SERVICE NOTICE**ISSUED BY TECHNICAL SERVICES**

Subject: DCPS660AG2 Oil Change Requirements

Service Notice No. **SN971**Date Code Range: **All**

Service Notice: Oil Change Maintenance Information for DCPS660AG2 PowerShift Rammer
Attention Technicians:

Fig. Q

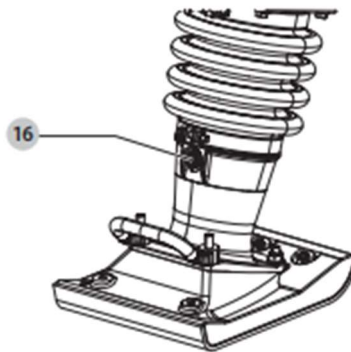
We have identified that the DCPS660AG2 manual is missing critical information regarding oil change requirements. Please follow the updated procedures below to ensure proper inspection and maintenance of affected units.

Oil Level Inspection (Refer to Fig. Q):

1. Place the rammer in a horizontal position.
 - **IMPORTANT:** Allow the rammer to rest for a few minutes so the oil can settle back into the housing.
2. Clean the oil sight glass (16).

3. Check the oil level.
4. The oil should reach at least the upper edge of the sight glass.
 - If the oil level is low, take the rammer to an authorized DeWALT service center for topping off or replacement.

- Oil should be replaced after every 200 hours of service or once annually, whichever comes first.

- Before each use, check the oil level. If the oil is low, refill or change the oil as needed (preferably at a service center).

- Use regular vehicle engine oil, 10W40 viscosity.
- Required quantity: 500 ml (16.907 oz).
